Date: June 12, 2023
Our Ref: 30064294
Subject: Remedial Investigation Work Plan Response to Comments
Former Chevron Bulk Plant No. 1001838
10 Fifth Street, Astoria, Oregon
ECSI #1402

FIGURE
B-1

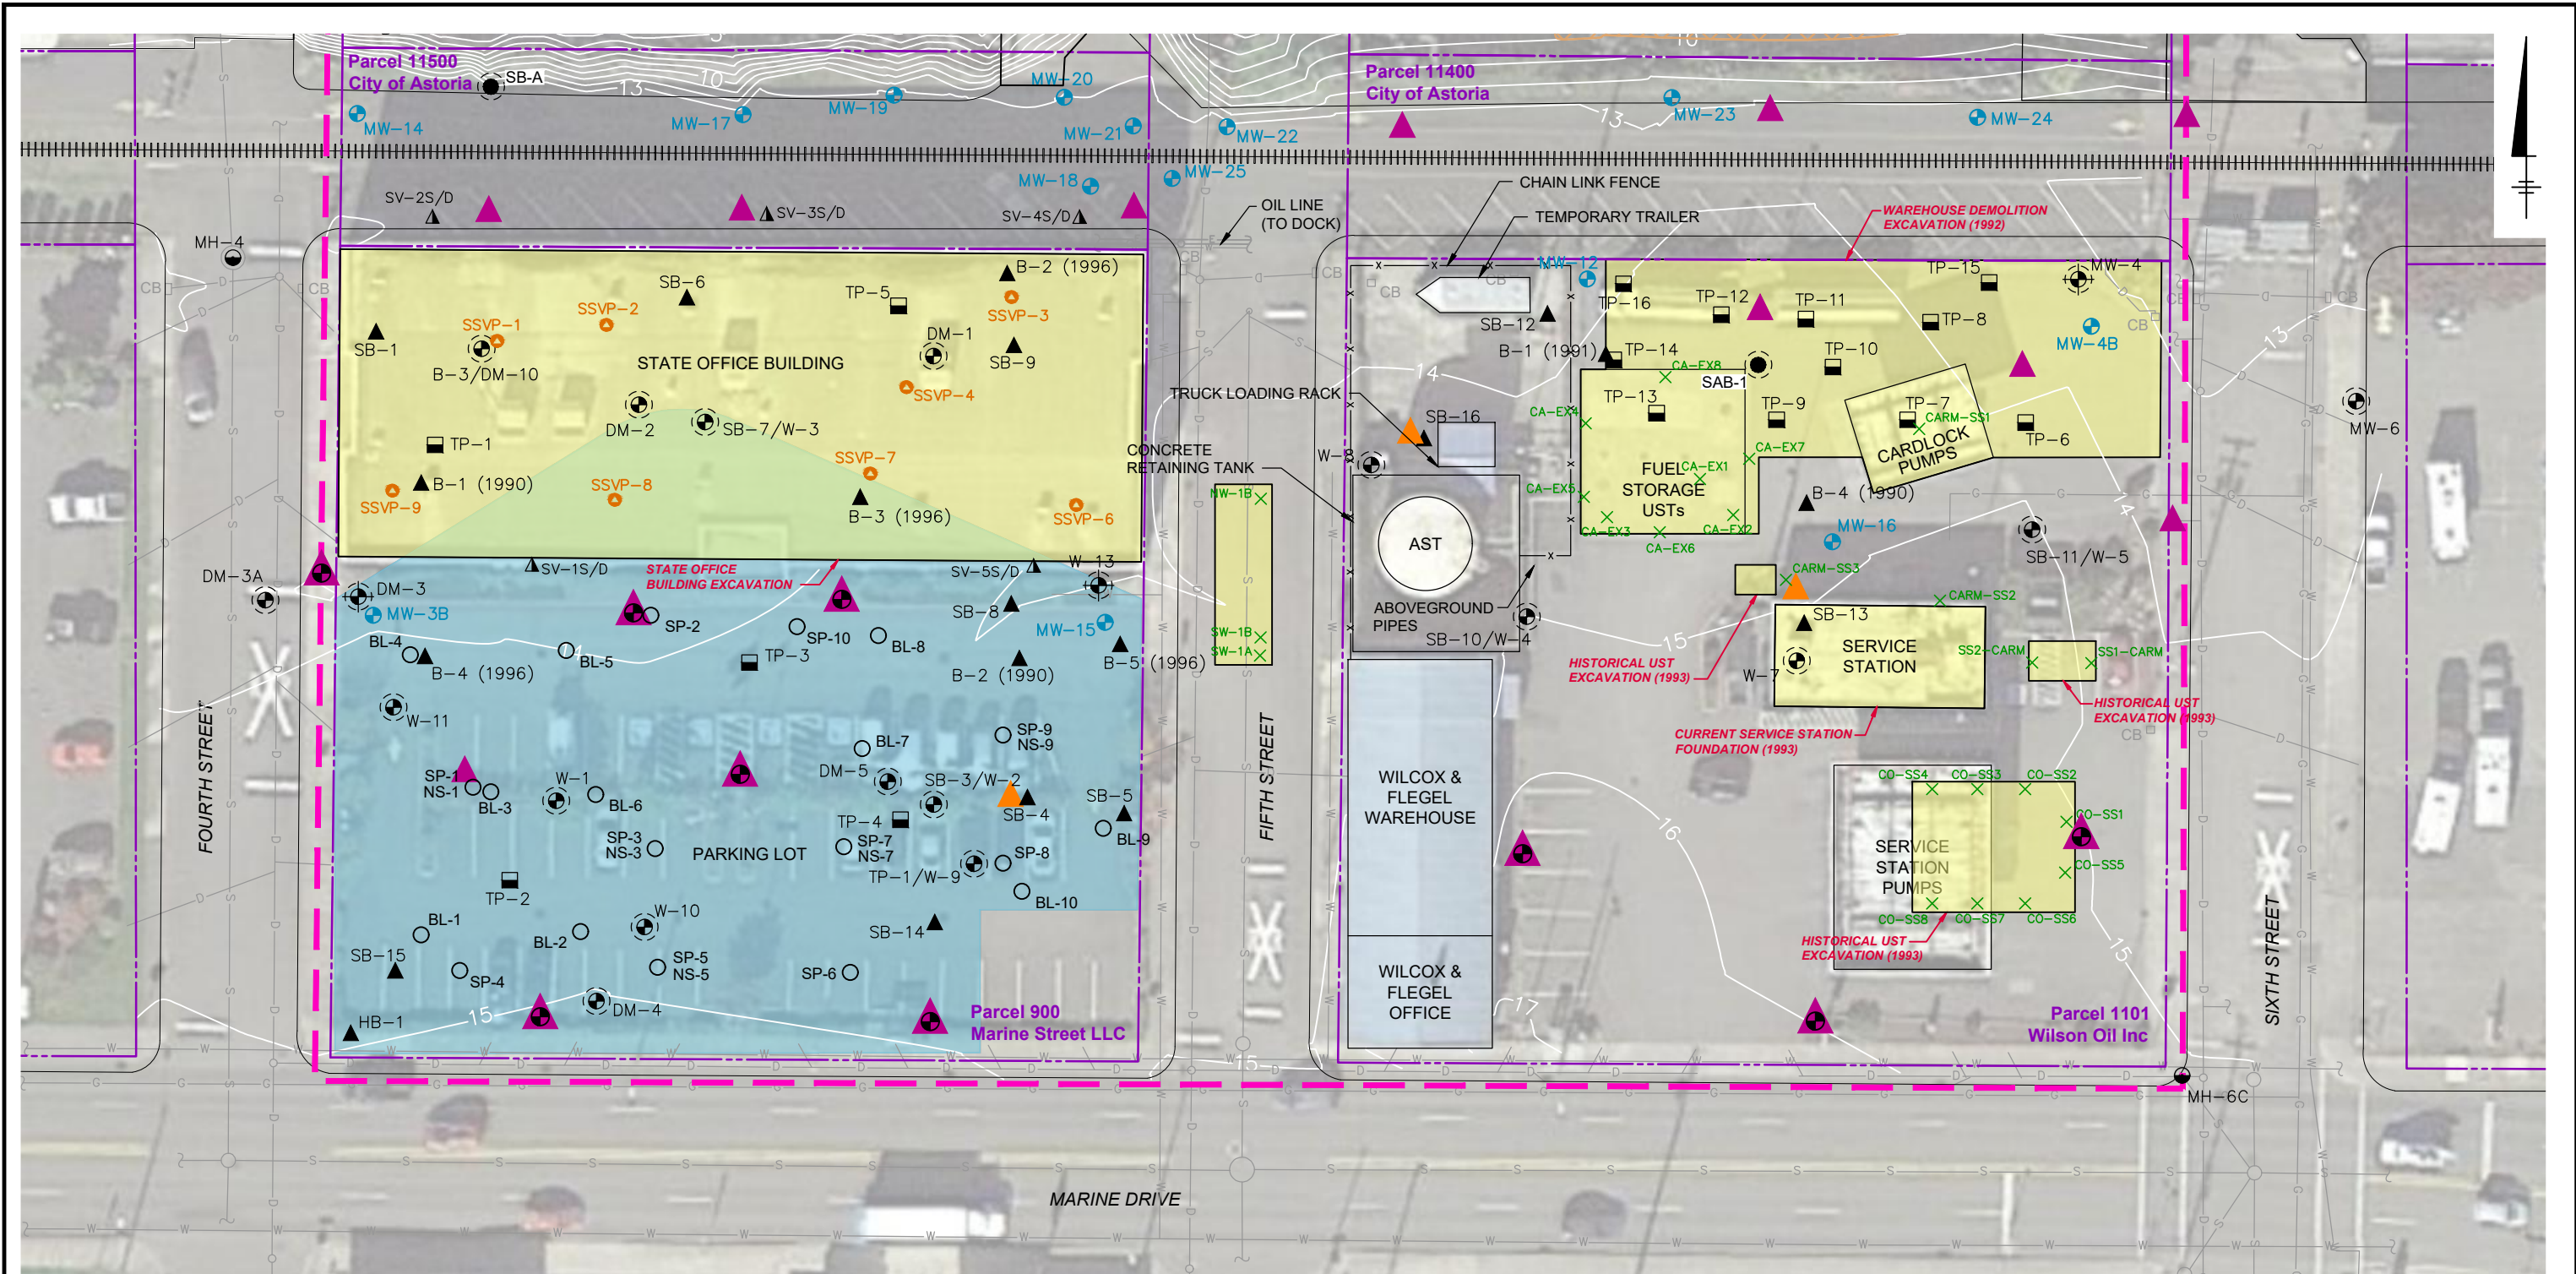
10. *Section 3.1, Soil Investigation, East Parcel: Several lines of evidence indicate significant groundwater concentrations on the east parcel to the east of Transect B (Figure 5). These include concentrations of iron, manganese, iron, barium, lead and petroleum. Additionally, there is a large uncharacterized area in the northeastern portion of the exposure area. Recommend another soil boring in this area upgradient of MW-24 near TP-6 / MW-4B where sheen and staining have been observed in soil.*

Arcadis proposes the drilling of an additional soil boring upgradient of MW-24 near TP-6/MW-4B and the collection of four north-south transects (top, mid, and lower) of bank soil samples as shown on **Figure B-1** and **Figure B-2**, respectively. Note that the final locations of the additional soil boring and the bank soil sample transects may be updated during field implementation based on potential refusal or utility conflicts.

FIGURE
B-2

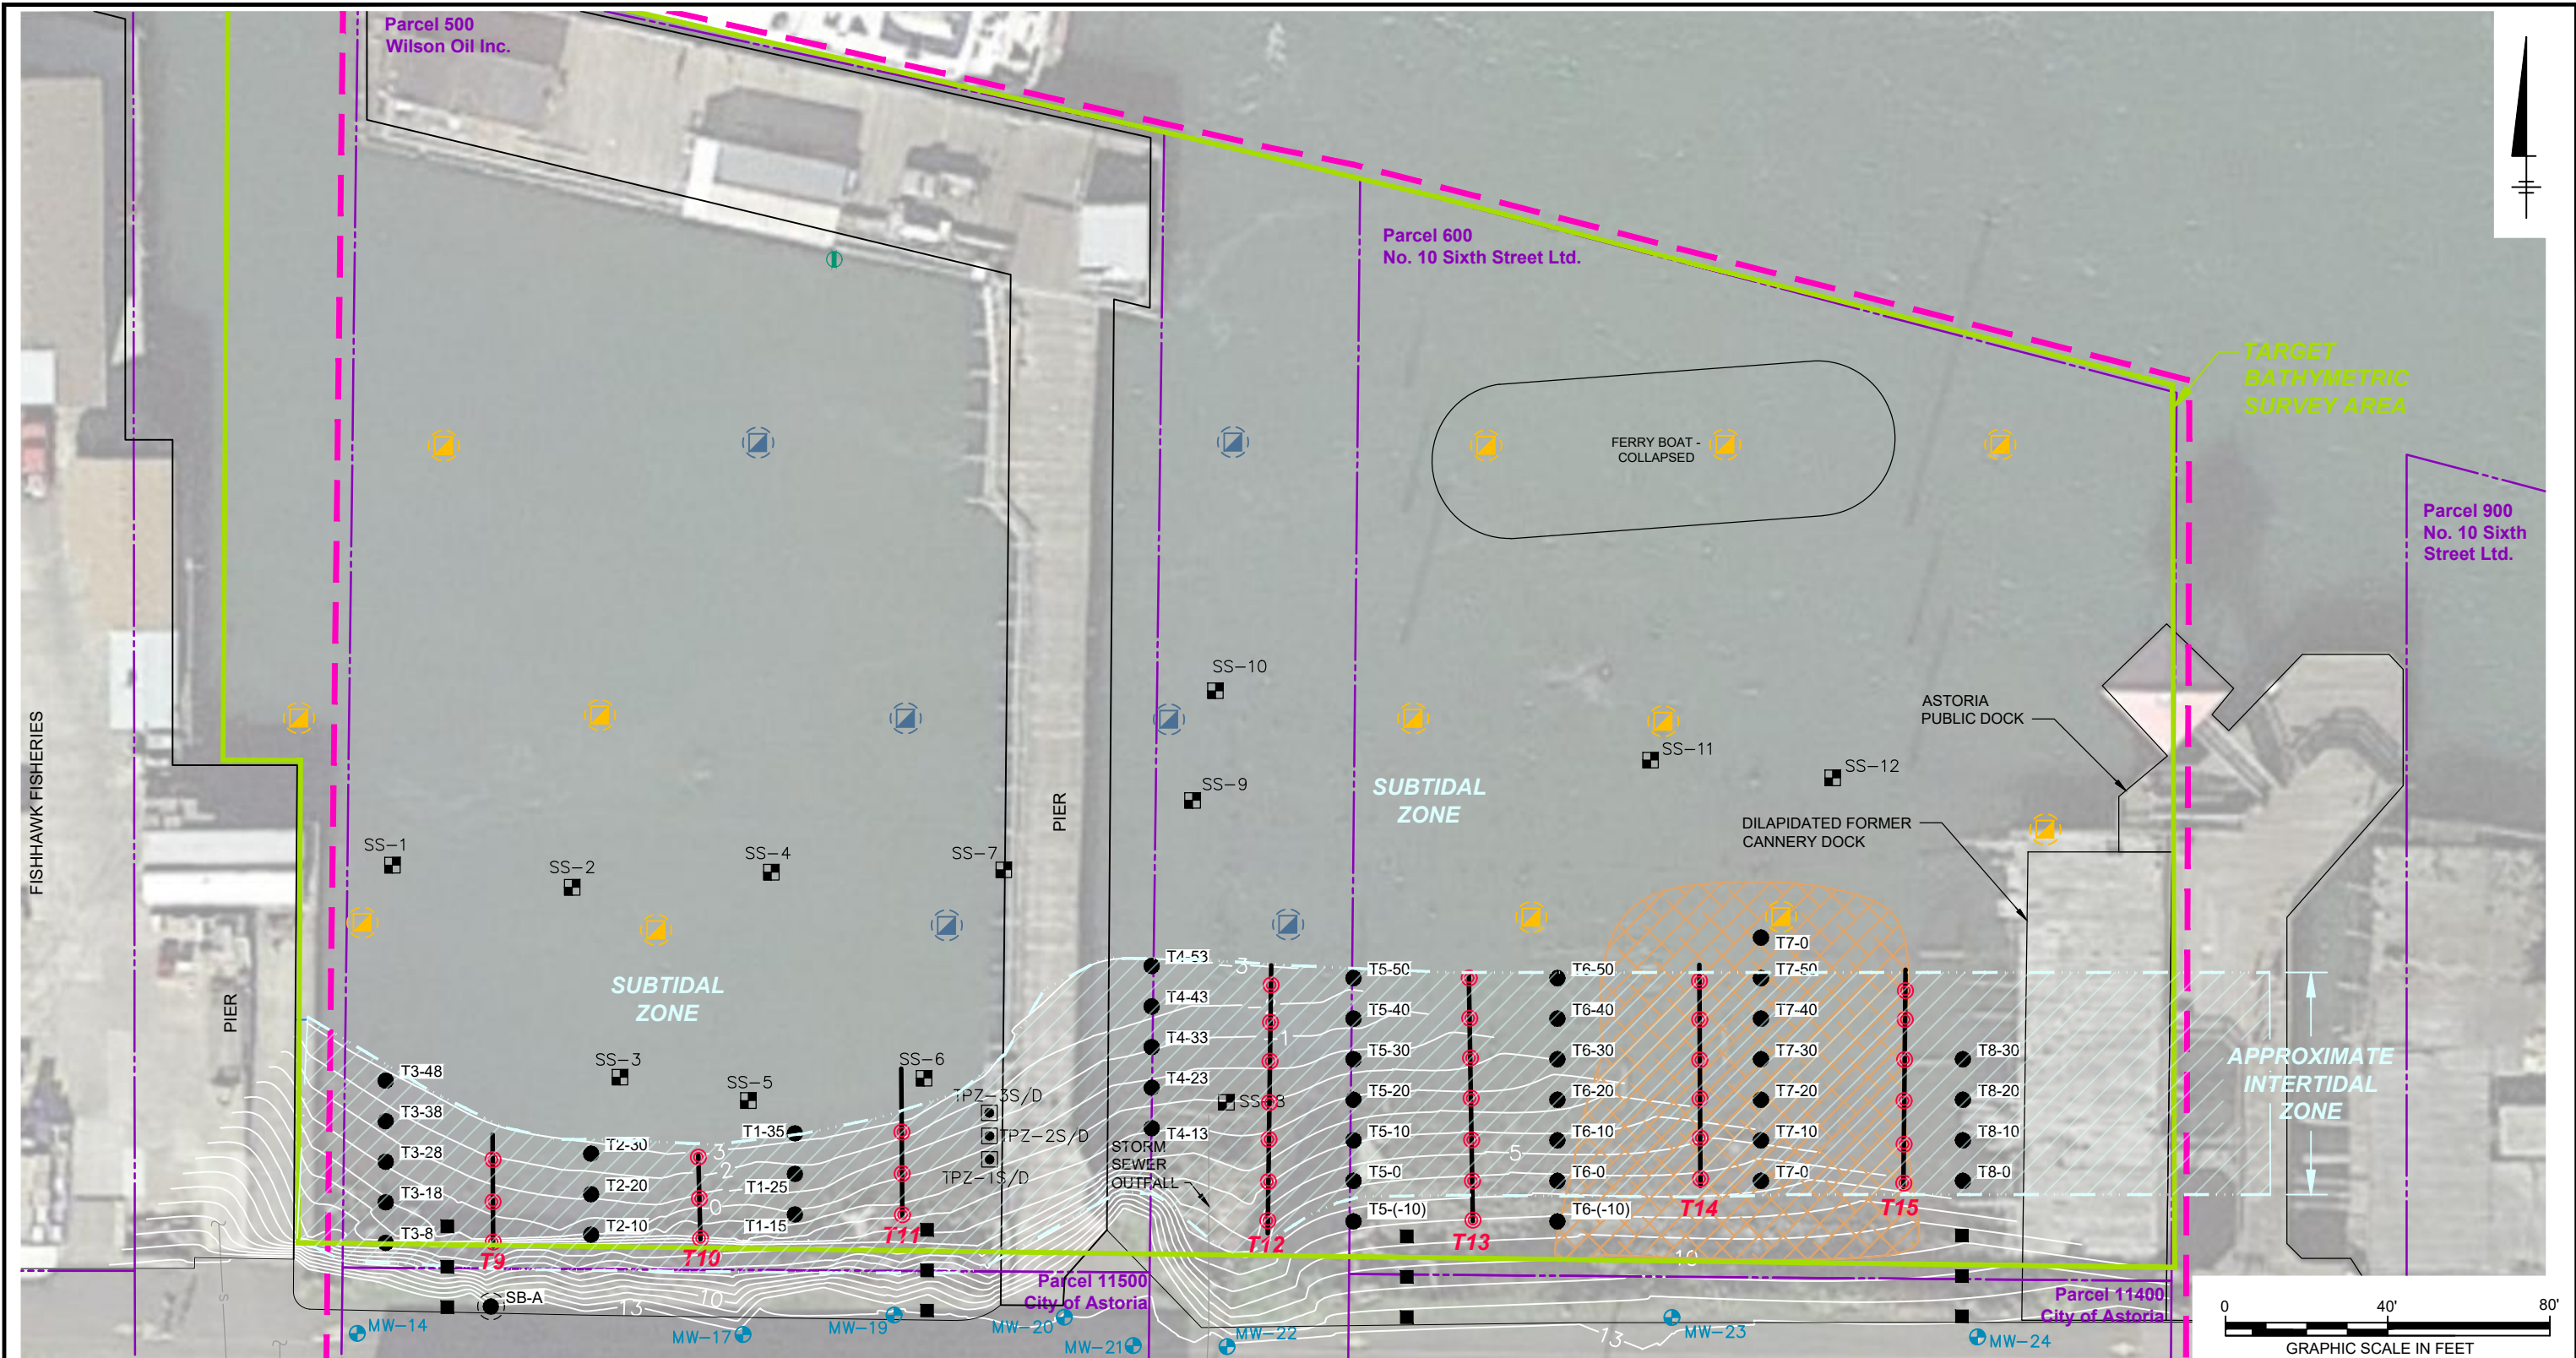
15. Section 7.3, *Preliminary Potential Receptors and Exposure Pathways*, references DEQ in 2010:

The text states “in-water exposure of residential or recreational receptors is likely an insignificant human health risk based on zoning and land use (DEQ 2010). Development since 2010 has improved public access with the addition of the Riverwalk, a paved recreational pathway. As a result, the top of bank, mid bank, and down to low water should be evaluated for human exposure (recreational users) and ecological risk. The general area that should be evaluated for recreational users is shown below. Recommend adding bank samples (top of bank, mid, lower, and down to low water) for the evaluation of human exposure and ecological risk. These data quality objectives should be included in Section 3.3 for the Shoreline and Intertidal Evaluation and samples should be collected with adequate spatial coverage to characterize this area and use as exposure point concentrations.
